## Top Cowl Unlatching – 1989-1991 135 thru 200

**MARINER AND MERCURY**  
**135-200**  
**S/N 0C100861-0D038616**

### Handle/Latch Kit P/N 813076A-2

### COMPONENTS IN KIT:

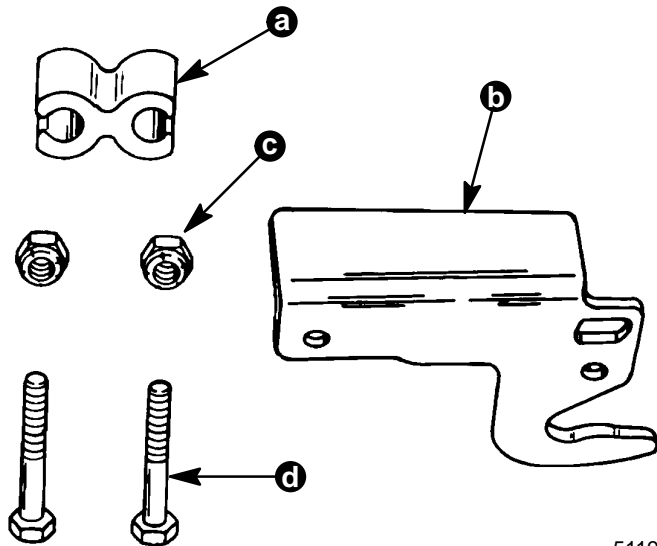
Outboard operation on extremely rough water may cause the front handle/latch to deform and not retain the top cowl as designed. To prevent the top cowl from unlatching, install Handle/Latch Kit P/N 813076A-2. The kit contains an improved (straight) front handle/latch P/N 813076--3, a special spacer for the roller assembly, fasteners and installation instructions. Also refer to service bulletin 90-4 for rear cowl latch changes for early models.

- a - Special Spacer
- b - Handle/Latch P/N 813076--3
- c - Lock Nut (2)
- d - Screw (2)

The improved front handle/latch P/N 813076--3 is factory installed on 135-200 models starting with serial number 0D038617.
